Subject: AUXILIARY PORT VALVE (APV) REMOVAL CAUTION	Bulletin No: 01-034/11
	Last Issued: 10/19/2011

2004-2008 Mazda RX-8 with High Power

2009-2011 Mazda RX-8

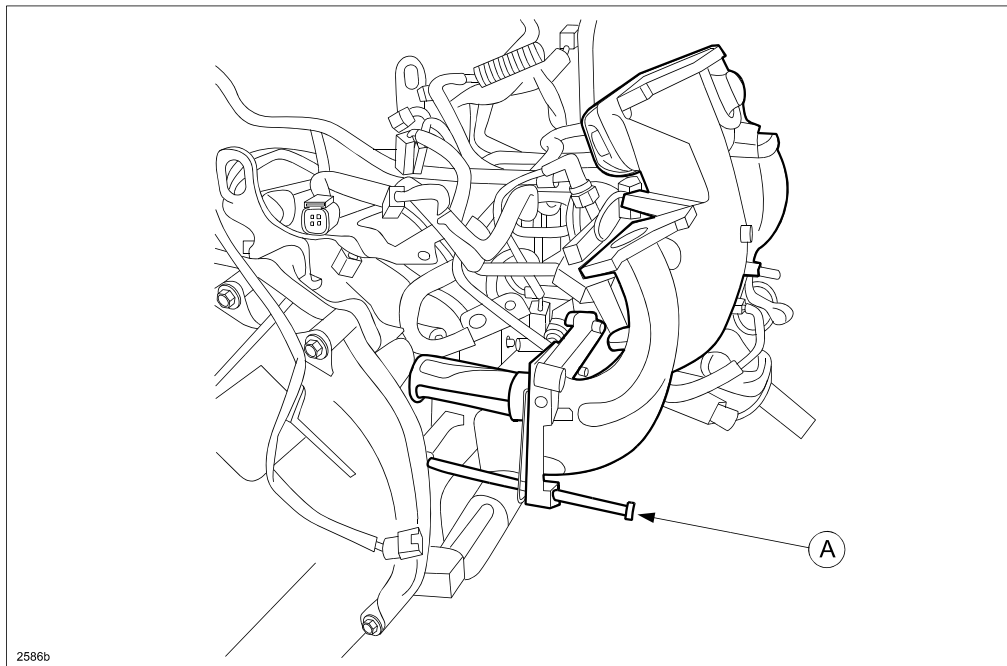
NOTE: When removing the inlet manifold, use two long bolts (A) [M8 - 1.25x220 hex bolt] in both the lower outer bolt holes to help support the manifold and slide out the APVs. This will take pressure off the APV arms so they will have less chance of breaking.

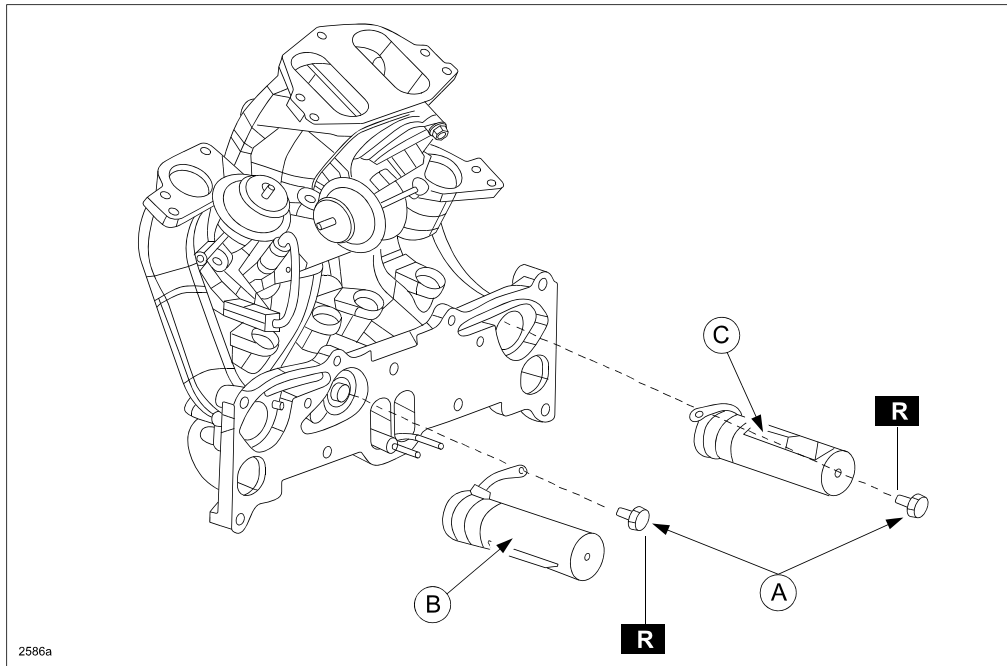
- If the APV is damaged during removal, remove the APV bolts (A), then remove the front APV (B) and/or the rear APV (C) from the inlet manifold and replace with a new one.

APV bolt tightening torque: 0.9-1.2 Nm (9.2-12.0 kgf-cm, 8-10 in-lbf)
